PROPOSED RULE/CODE CHANGE REQUEST

Michigan Department of Licensing and Regulatory Affairs Bureau of
Construction Codes/Operations Section

210.8(F) Outdoor Outlets.

Figure 1: GFCI Protection in Homes Versus Electrocutions 1975 to 2018 (Source: A NEMA Ground Fault Personnel Protection Section Article entitled “GFCI Receptacles: Consumer Protection Personified” June 2020, Revision 2).

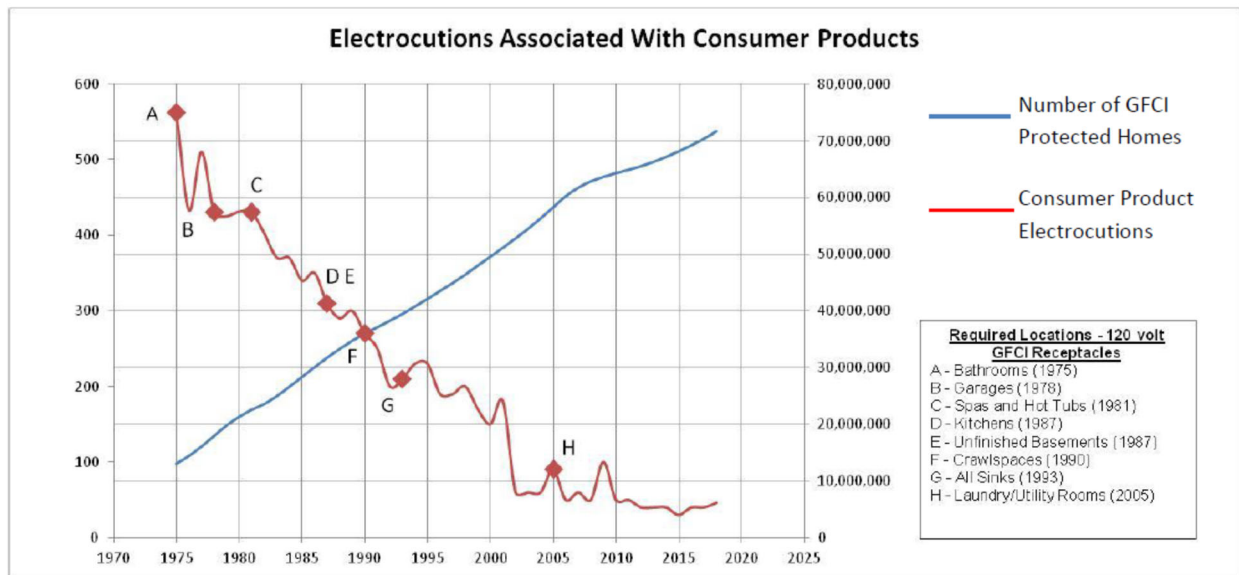
Continued expansion of GFCIs to all areas of a home is not justified. Finished living areas of basements are not as hazardous as areas such as bathrooms or kitchens where people use small appliances near sinks and tubs, and no data was presented to prove otherwise. GFCI receptacles were first required in the 1987 edition of the code and expanded to the entire unfinished area of basements in the following

edition. For the past 30 years, this provision has been adequate which highlights the lack of any known benefit gained by expanding GFCIs to all areas of finished basements. (See Figure 1.)
